# DD15™ Fuel System Technician's Guide

**NUMBER:** 08 FSTG-7   **S.M. REF.:** 24   **ENGINE:** DD15   **DATE:** September 2008

**SUBJECT:** NEW SPN 157

**PUBLICATION:** DDC-SVC-MAN-0037

d150007a

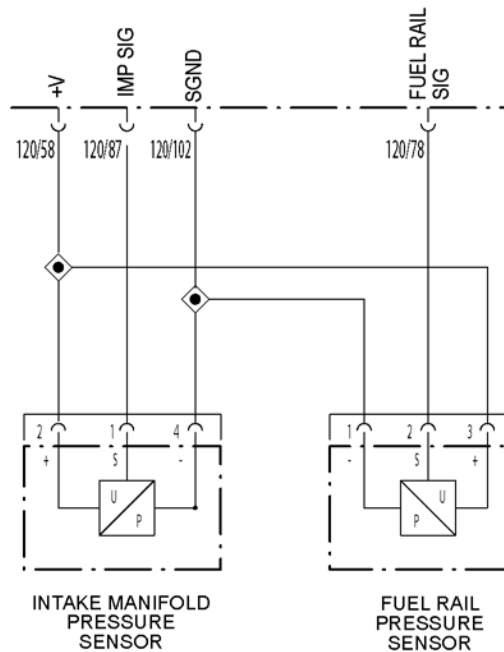
SPN 157 has been added to the manual.

This diagnostic condition is typically an erratic Fuel Rail Pressure Sensor signal.

1. Disconnect the Fuel Rail Pressure Sensor.
2. Inspect the Fuel Rail Pressure Sensor harness connector for loose, bent, spread or corroded pins.
  - [a] If pin damage is found, repair as necessary. Verify repairs.

- [b] If no connector damage is found, go to the next step.
3. Disconnect the MCM 120-pin connector.
4. Inspect pins 58, 78, and 102 for bent, spread or corroded pins.

- [a] If pin damage is found, repair as necessary. Verify repairs.
  - [b] If no connector damage is found, go to the next step.
5. Connect DDDL 7.X.
6. Turn the ignition ON (key ON, engine OFF).

7. Under the “Actions” drop down menu, select “PLV Change.” On the PLV Change screen select “Read Accumulator.”
  - [a] If the PLV counter is greater than 50, the PLV must be replaced. After PLV replacement, reset the PLV accumulator value via the “Reset Accumulator” button.

- [b] If the PLV counter is less than 50, troubleshooting is complete.
